Los Angeles to Pasadena Metro Blue Line Construction Authority
Los Angeles to Pasadena Metro Blue Line Light Rail Project

Value Engineering Study Report

Preliminary Basis for Design/Build Design

December 22, 1999

ALTERNATIVE NO.
DMMP-12
Sht. 2 of 7

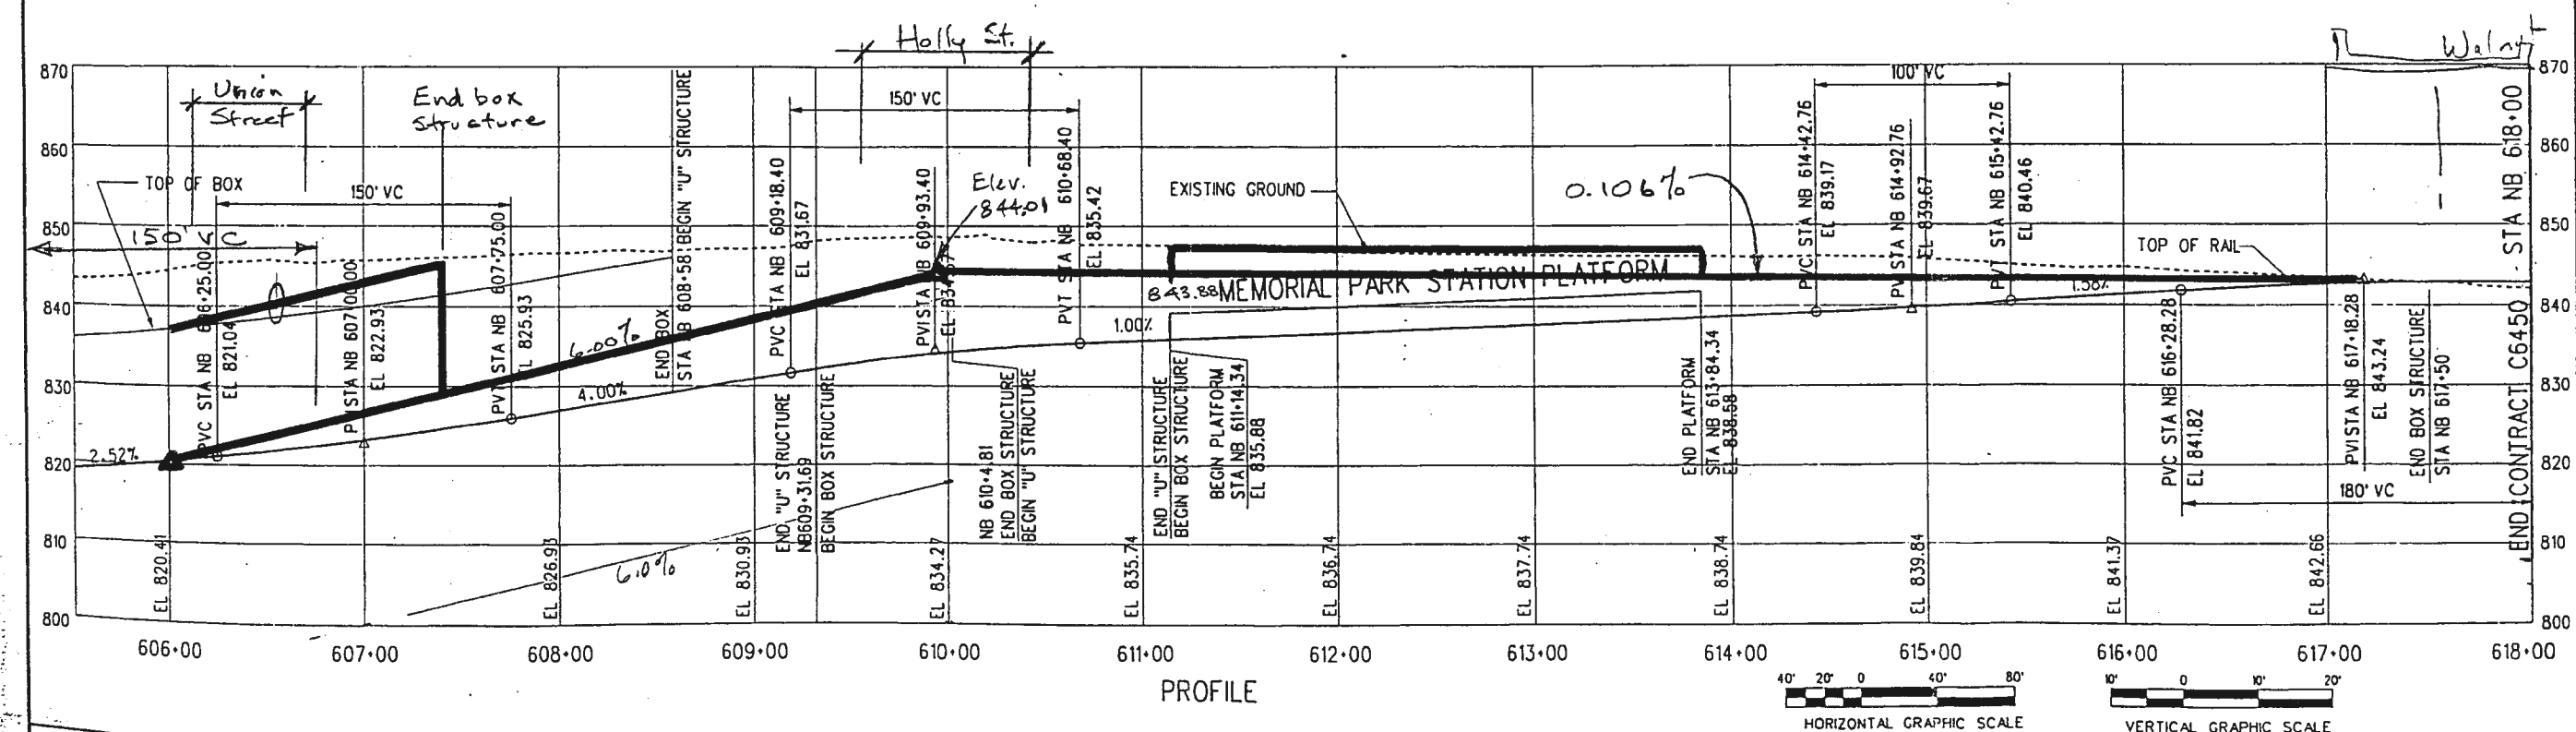
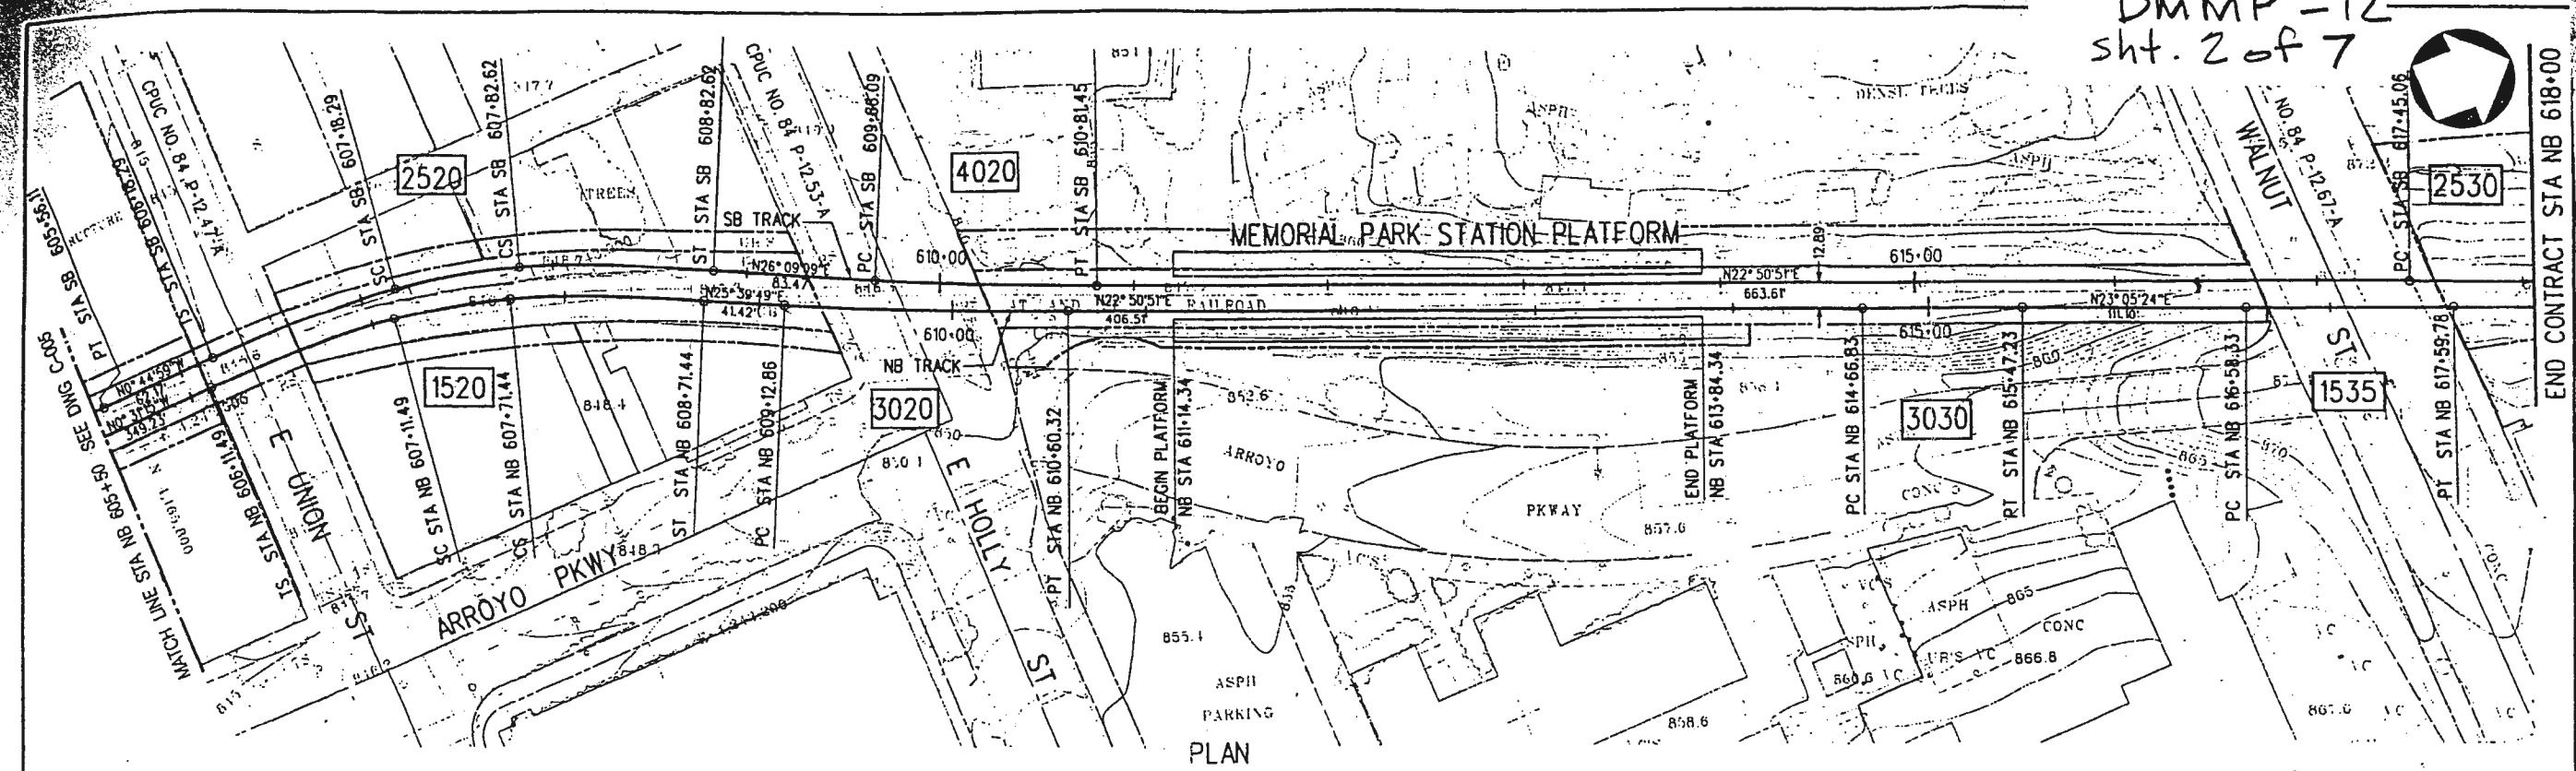
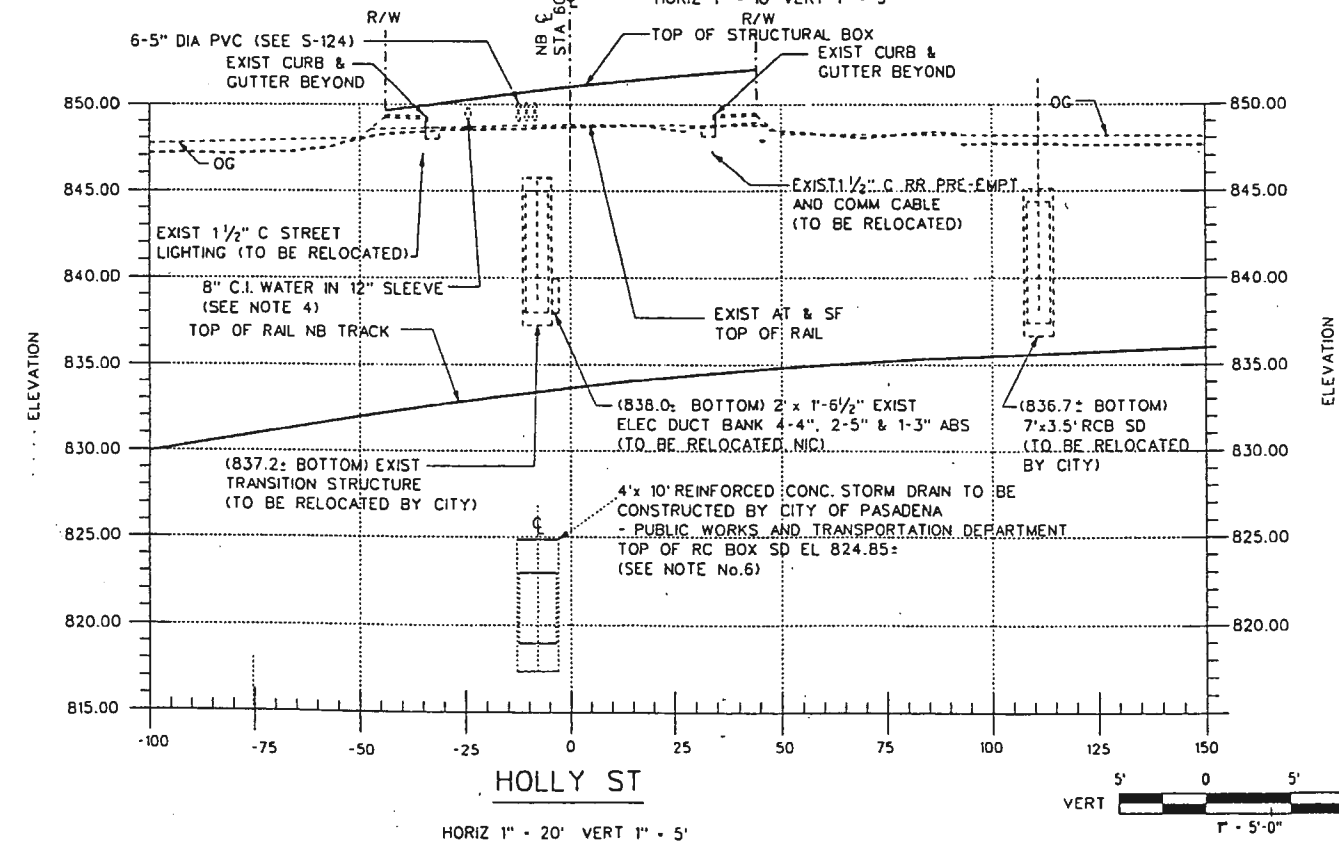
DMMP-12	Close Holly Street to vehicular traffic and raise track profile at Memorial Park Station	2,769,000	1,431,000	1,338,000	—	1,338,000
DMMP-15	Replace floating slab with vertical vibration isolation walls	4,297,800	3,532,860	764,940	—	764,940

ALTERNATIVE NO. DMMP-15

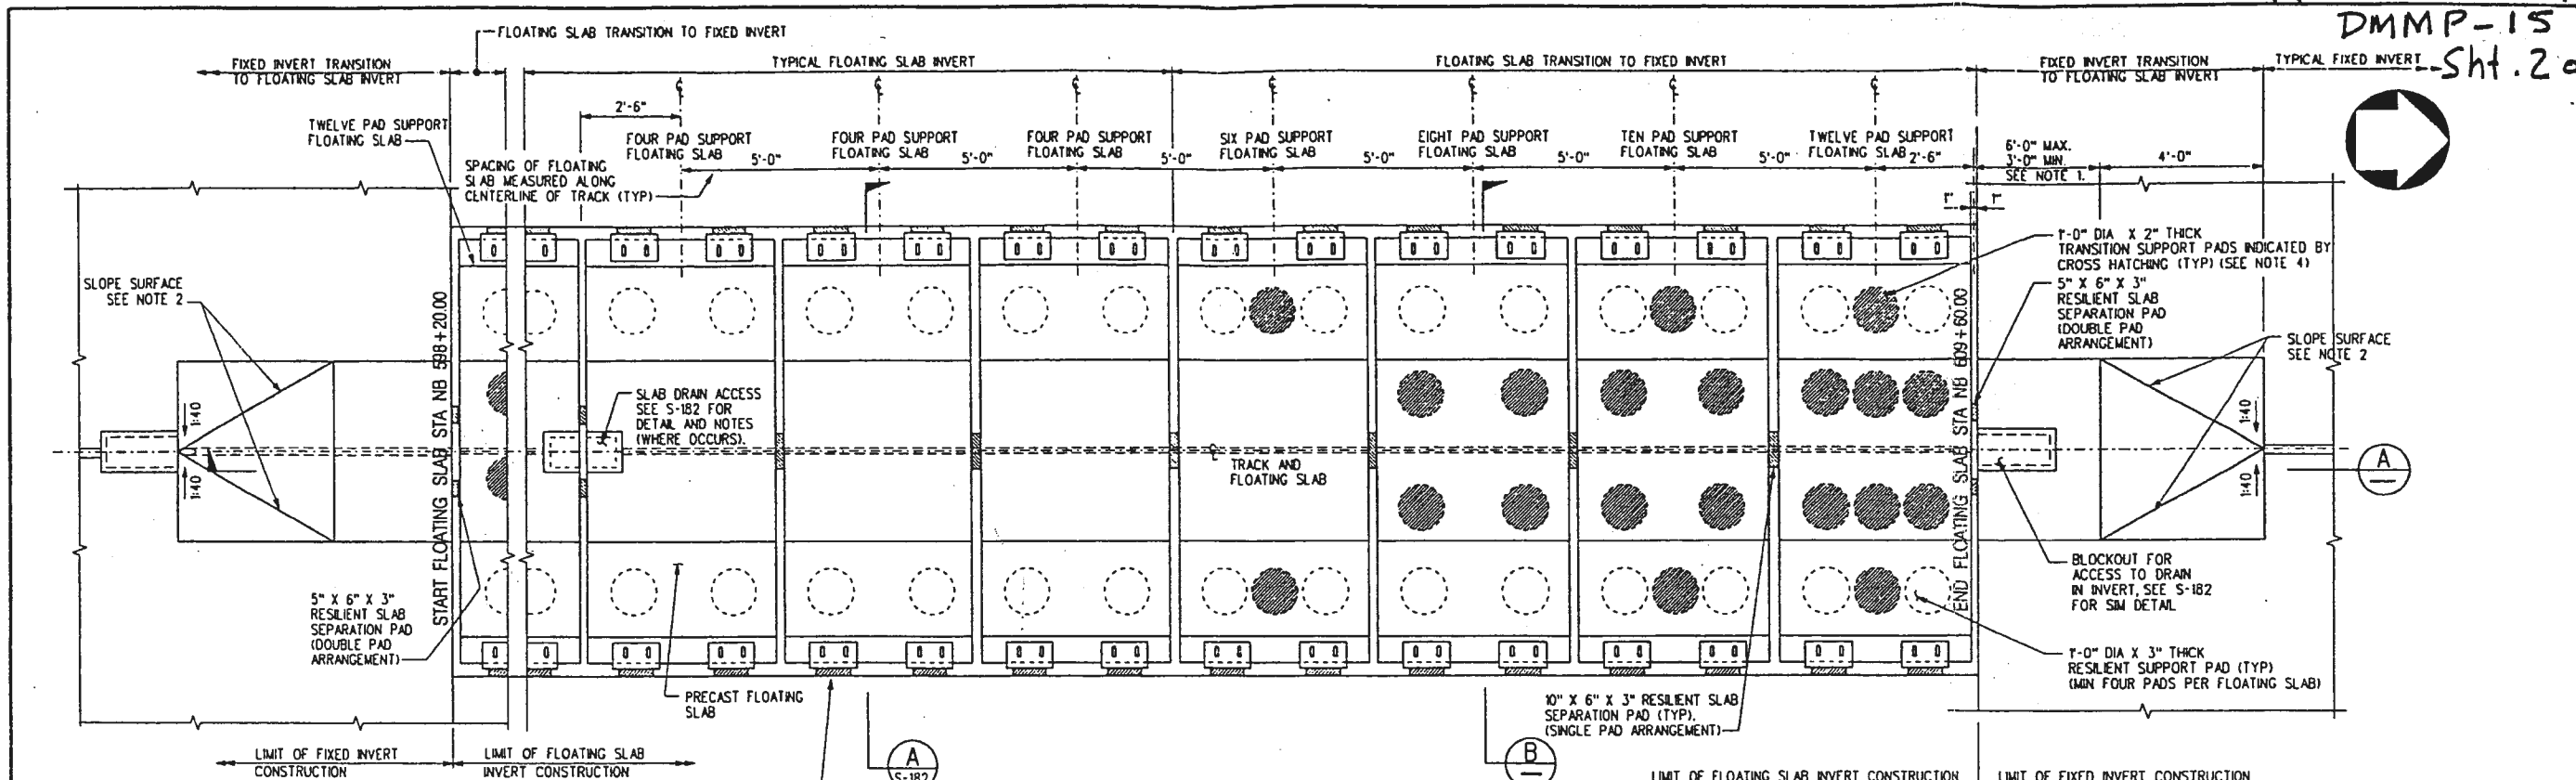
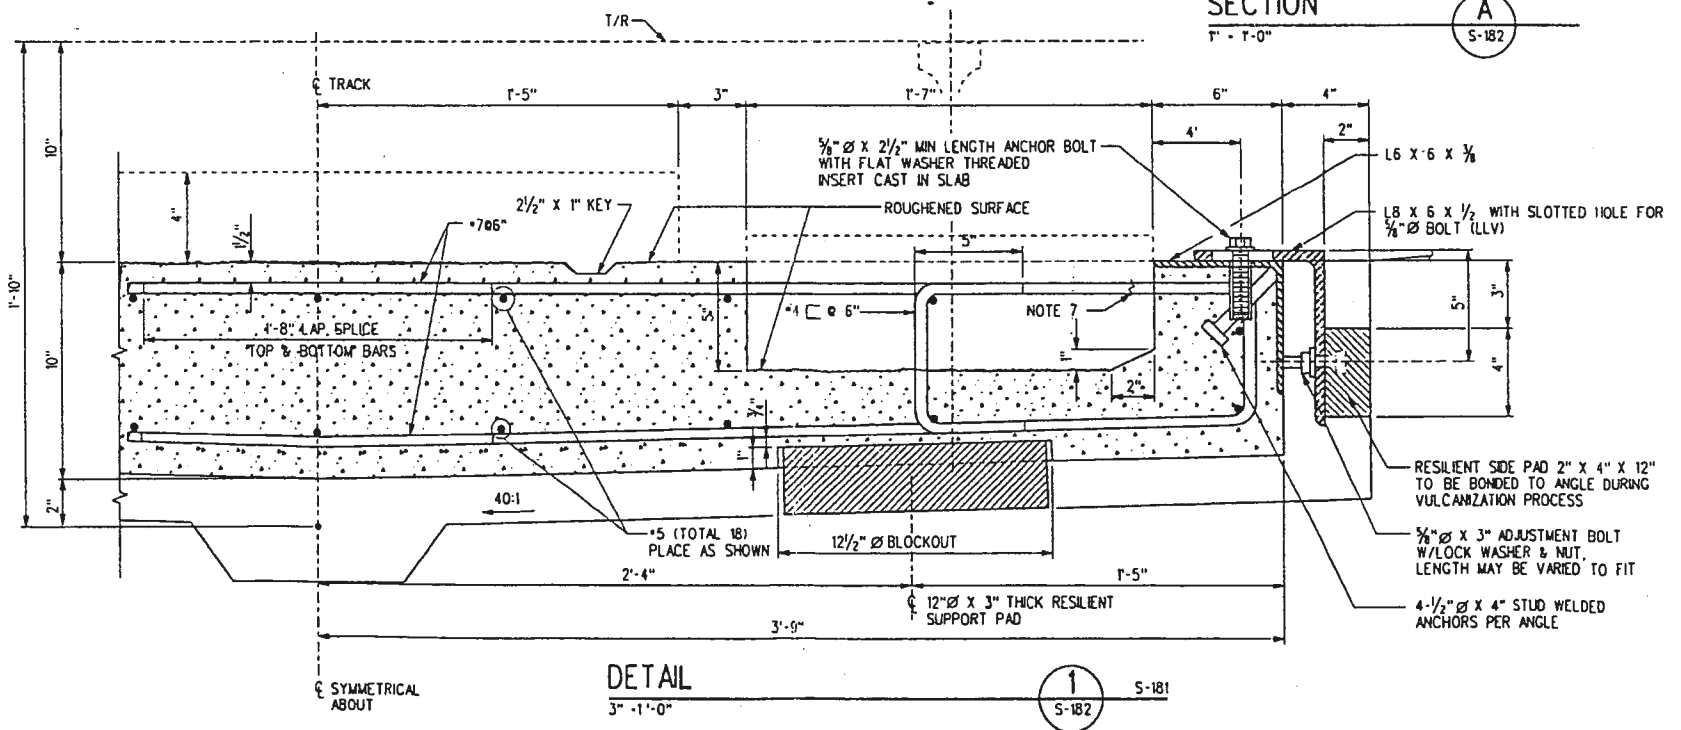
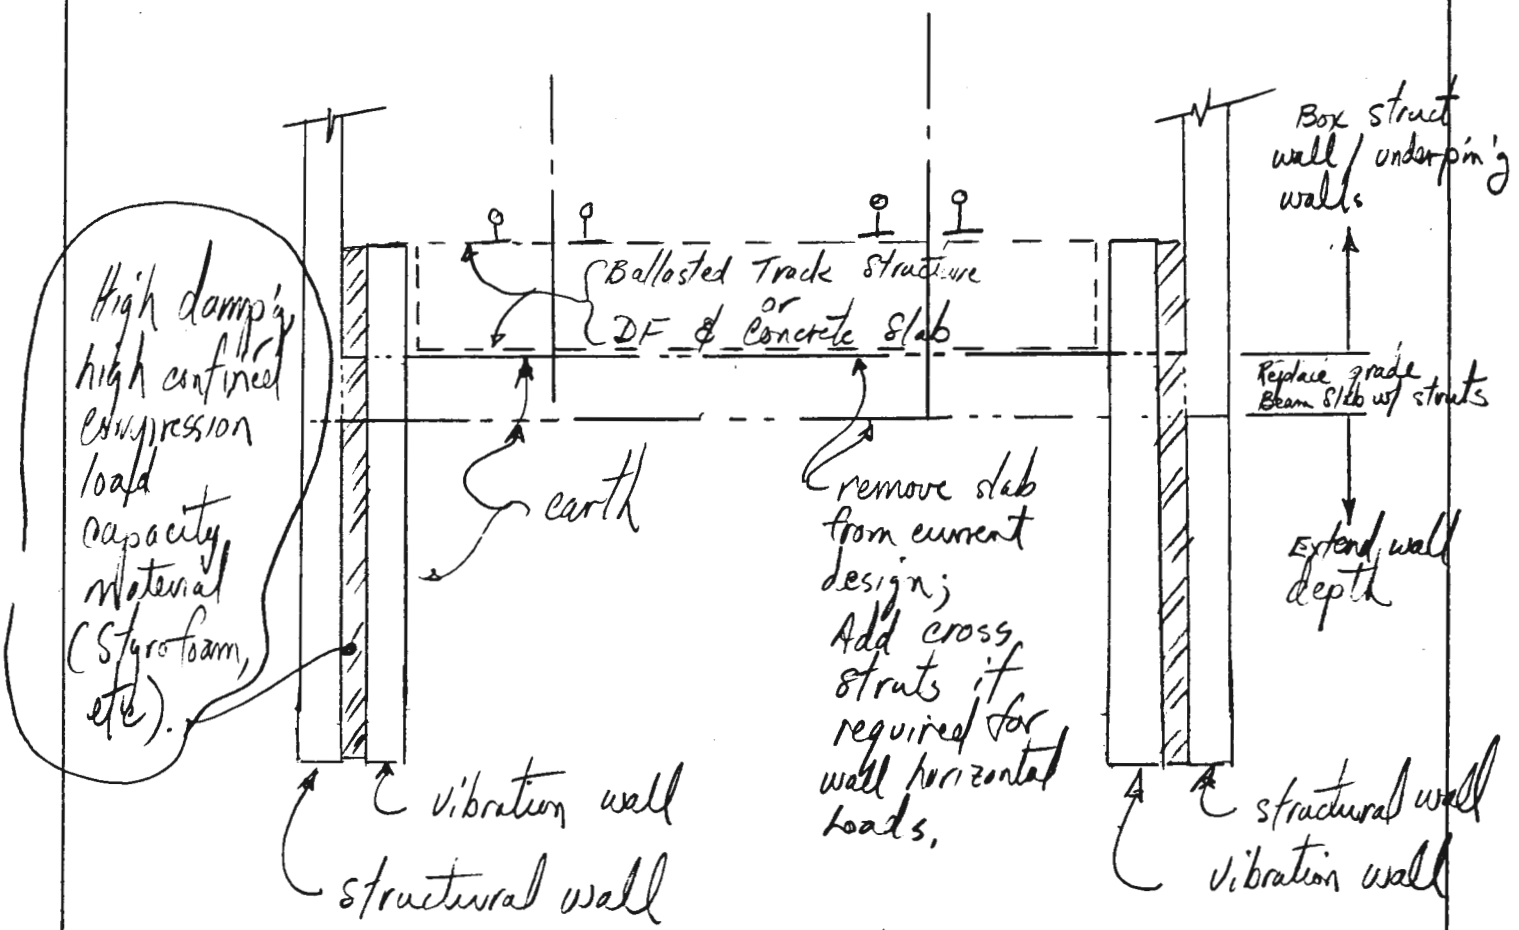
As designed, the Memorial Park Station requires extensive modification to the apartment building foundation that is to sit above it. This includes underpinning and the elimination of grade beams that provide lateral support for the building columns. The grade beams must be replaced with an alternative support system. By raising the grade of the tracks south of the station and providing a cul-de-sac for the west leg of Holly Street, the station can be raised thus eliminating most of the foundation work and saving substantial costs. Raising the station also allows for improved integration into the adjacent park as shown in Alt. No. DMMP-12. There also is a potential to eliminate the floating slab at the station to save costs, which is documented in Alt. No. DMMP-15.
